# Access Compliance Report

## Public Rights-of-Way

### (Curb Ramps)

Intersection ID: 30057	Main Street: SOUTHWIND_DR	Cross Street: SUNSET_VILLAGE_DR	Location:	N
ADA ID: AF29D64AF695	Ramp Type: Combination1Diag	Initial Pass/Fail: Fail	Overall Compliance: No	Severity Score: 0

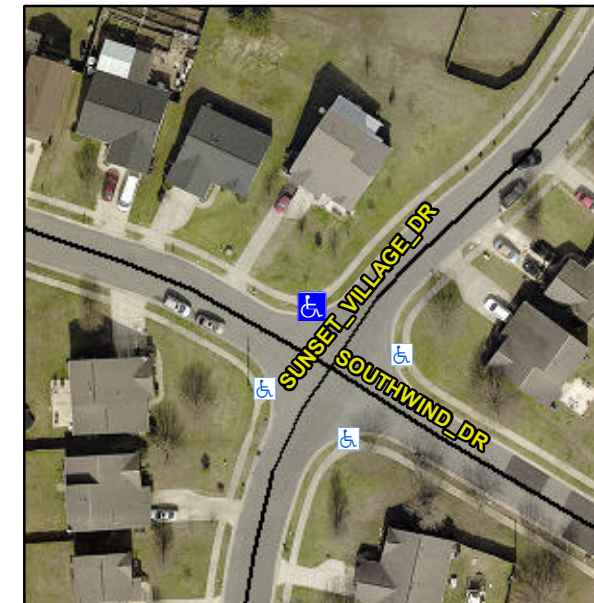
**R304.5.3, R304.3.2**

Compliance	Description	Data	Compliance	Description	Data
N/A	Ramp Length LT (in)	46.0	N/A	Ramp Length RT (in)	46.0
Yes	Ramp Width LT (in)	59.0	Yes	Ramp Width RT (in)	60.5
No	Ramp Slope LT (%)	9.2	Yes	Ramp Slope RT (%)	5.0
Yes	Ramp XSlope LT (%)	1.4	Yes	Ramp XSlope RT (%)	0.4
N/A	Ramp Length (in)	55.5	Yes	Ramp Slope (%)	6.9
Yes	Ramp Width (in)	54.0	No	Ramp XSlope (%)	4.0
N/A	Flare Type LT	N/A	N/A	Flare Type RT	N/A
N/A	Flare Slope LT (%)	N/A	N/A	Flare Slope RT (%)	N/A
N/A	Flare Traversable LT?	N/A	N/A	Flare Traversable RT?	N/A
N/A	Landing Length (in)	N/A	N/A	DWS Provided?	N/A
N/A	Landing Width (in)	N/A	N/A	DWS Contrast?	N/A
N/A	Landing Slope (%)	N/A	N/A	DWS Length (in)	N/A
N/A	Landing X Slope (%)	N/A	N/A	DWS Full Width?	N/A
N/A	Landing Curb? (Y/N)	N/A	N/A	DWS Offset (in)	N/A
N/A	Shared Landing?	N/A			
N/A	Gutter Ponding?	N/A	N/A	Gutter Slope (%)	N/A
N/A	Gutter Lip Ht (in)	N/A	N/A	Gutter X Slope (%)	N/A
N/A	Painted X Walk1?	No	N/A	Painted X Walk2?	No

**Remove & Replace Curb Ramp With Two New Directional Ramps or Equivalent.**
